OPERATOR: F3 Gold, LLC.
PERMIT NUMBER: EXNI-436
INSPECTION TYPE: Pre-Inspection

DATE: September 23, 2020

Photo 4. Jenny Gulch Creek Valley.

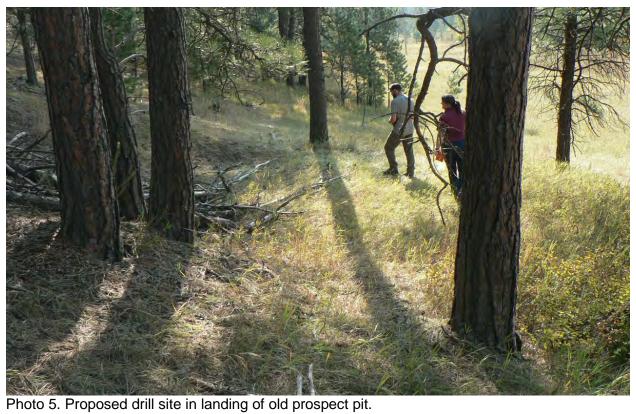
From proposed Hole 003, the group hiked across the Jenny Gulch Creek Valley (photo 4) and began traversing the opposing hillside back towards the south. Several proposed drill sites were located along this hillside. The holes had mostly been moved out of the Jenny Gulch drainage at the request of the USFS in order to prevent impacts to the immediate drainage. While walking along the hillside, Mr. Isakson noted a new road would need to be constructed along the distance for these proposed sites. He estimated the road would be built as much along flat areas as possible, though for the most part it appeared to be primarily located just within the tree line on this side of the drainage. Some of the road may need to be cut into the hillside with a dozer. Some thistle and mullein noted along the route of the road may need to be sprayed during the exploration operation.
